PCI DESIGN HANDBOOK

8TH EDITION ERRATA

Eighth Edition Errata

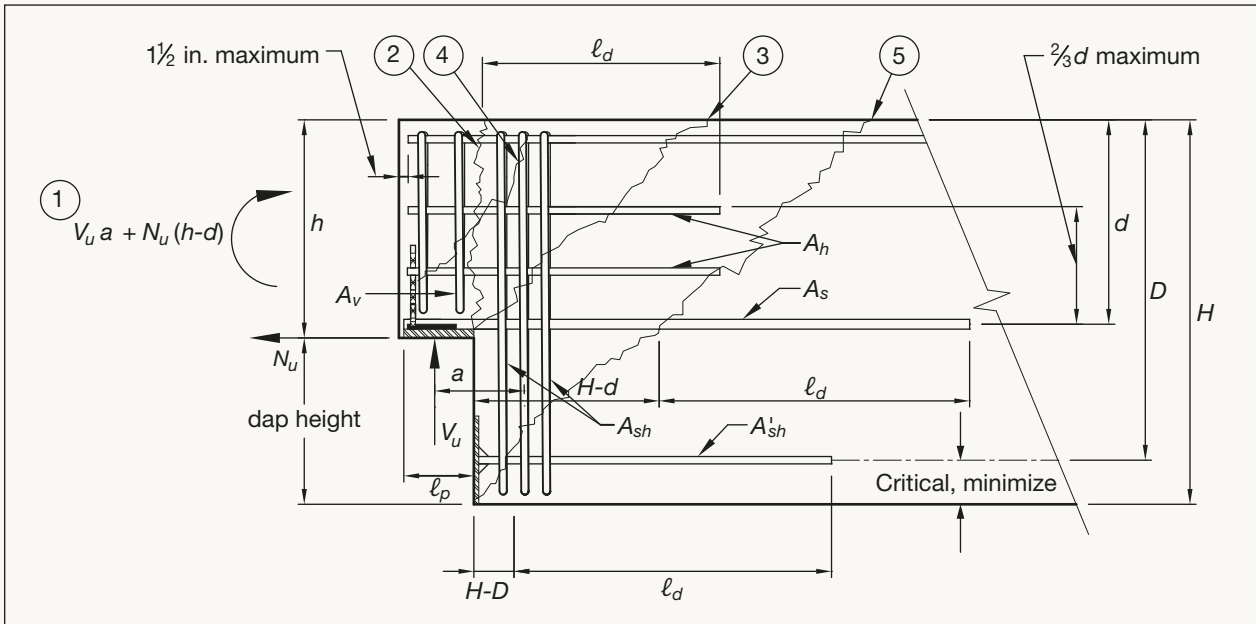
Page 5–76, Figure 5.5.3, top figure: Replace figure with the following to remove “Center of gravity of flexural reinforcement” and associated leader line at bottom of figure and to add “Critical, minimize” and associated dimension lines:

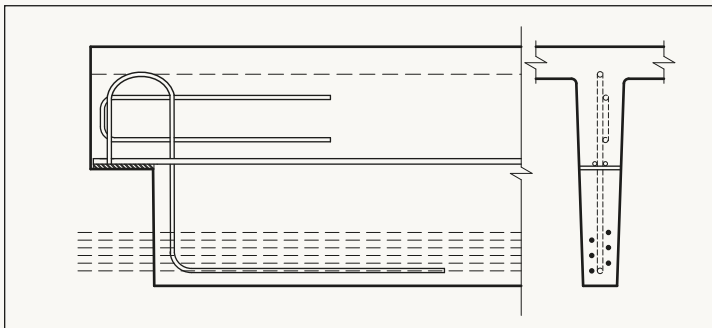
Page 5–77, Figure 5.5.4 (b): Replace figure with the following to delete the dowel bar and vertical plate at the bearing angle:

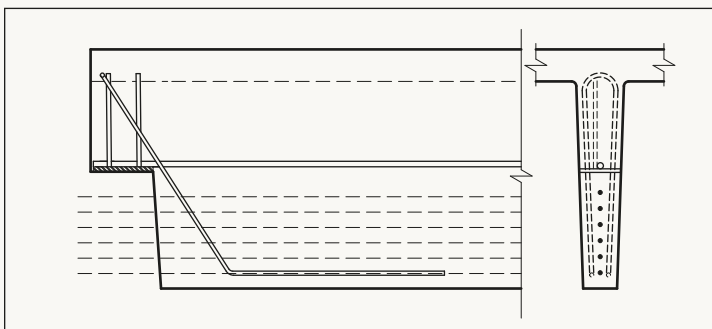
Page 5–77, Figure 5.5.4 (c): Replace figure with the following to delete the C-shaped A_h reinforcement:

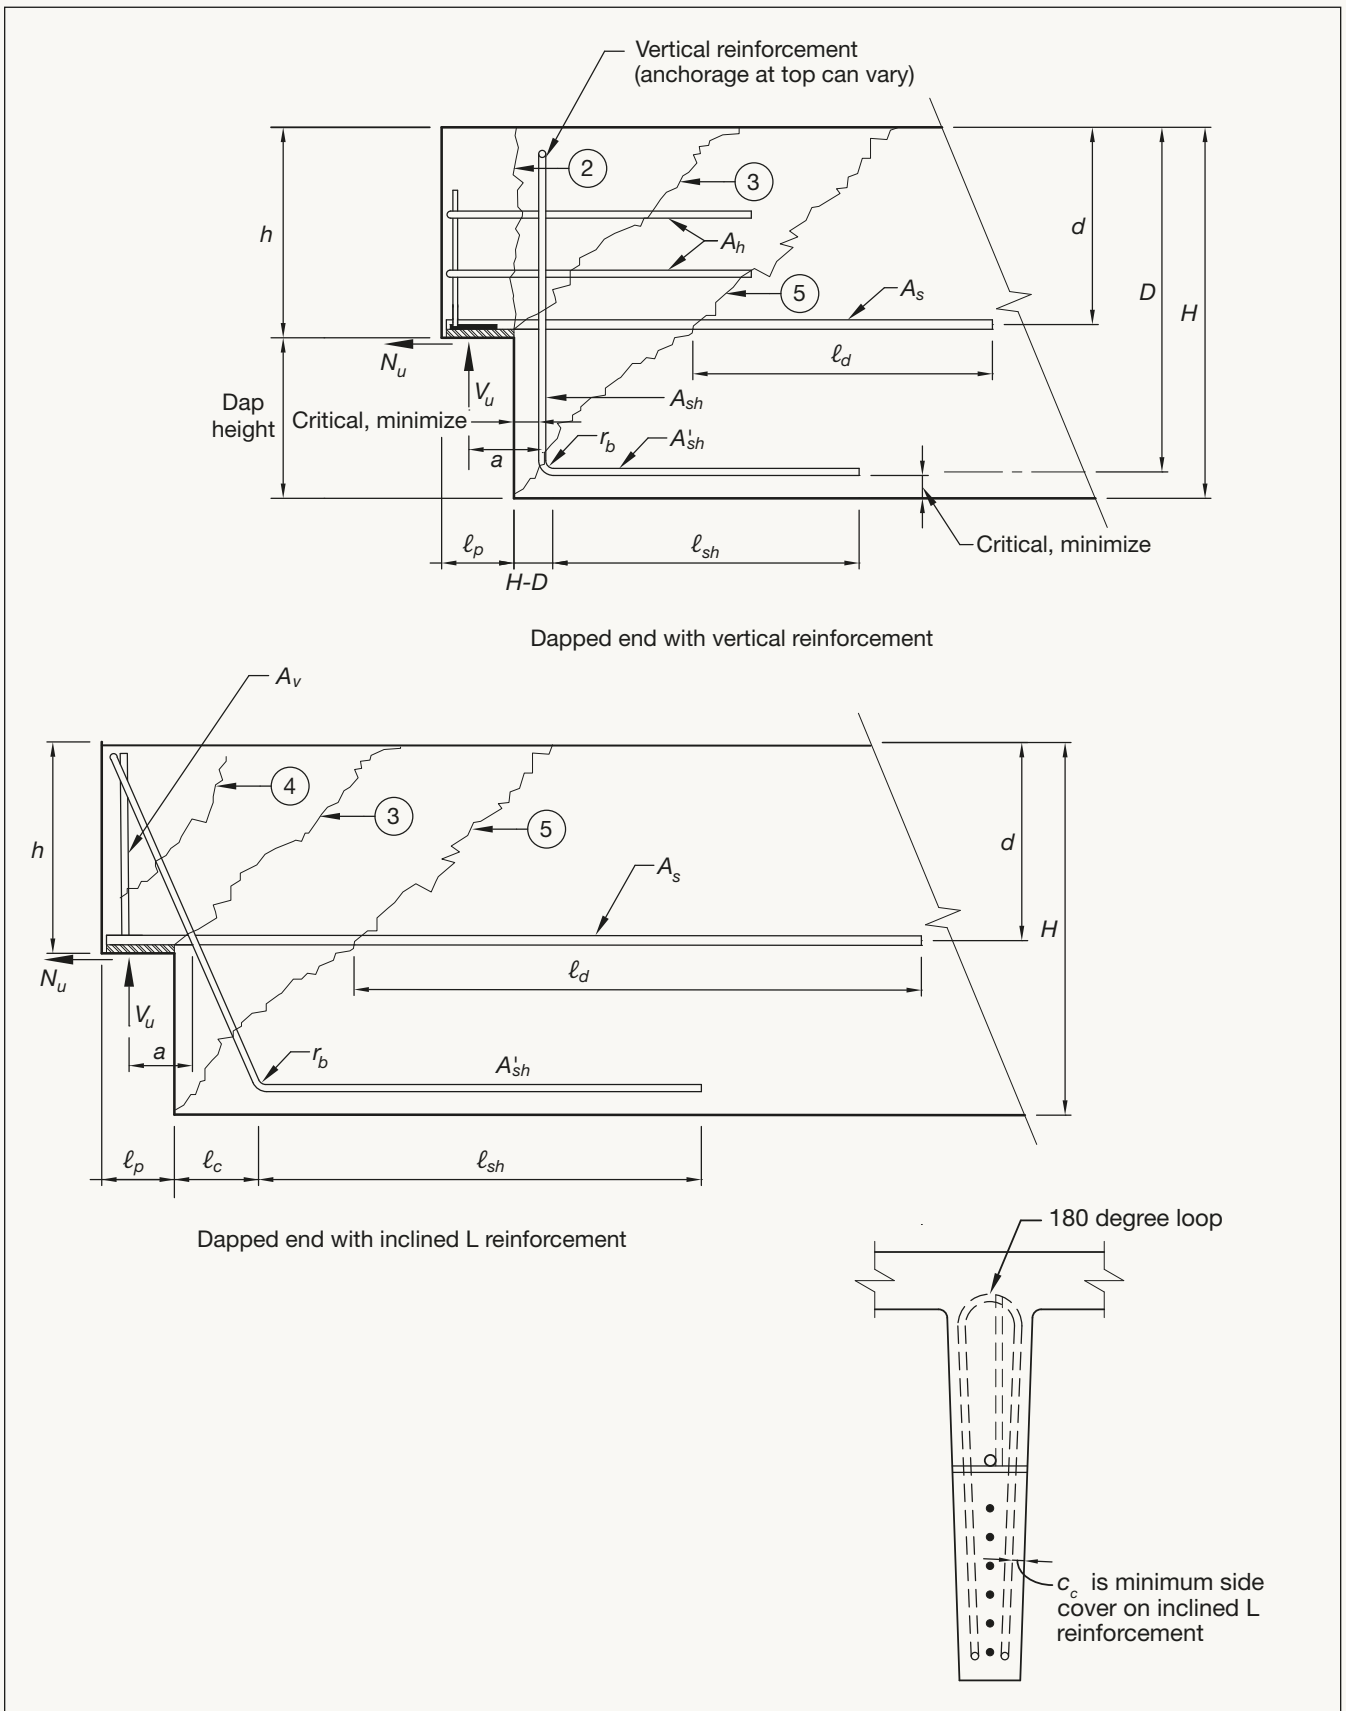
Page 5-78, Figure 5.5.5: Replace figures with the following. Changes include adding the vertical crack 2 on the top and crack numbers on the bottom figure, revising the length of the A_s on the bottom figure, and deleting the $2h$ dimension line and A_h on the section:

Page 5–78, Figure 5.5.5: Add the following note to figure: “Note: See Eq. 5-73, 5-74, and 5-75 for limits on the shear strength for a distance of $2H$ beyond the dap.”

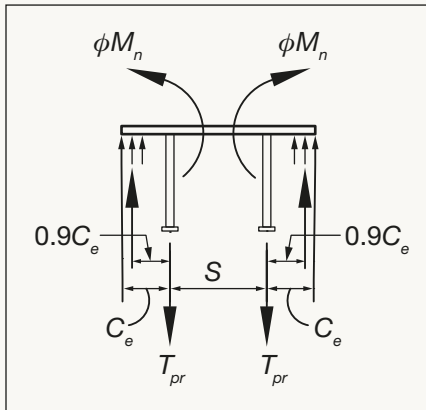
Page 6–19, Example 6.5.2.1: Replace figure on the left with the following:

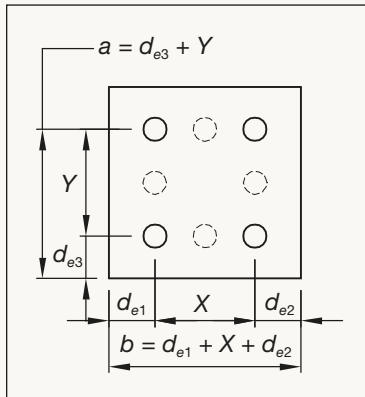
Page 6–122, Design Aid 6.15.11, Case 6: Replace figure with the following:
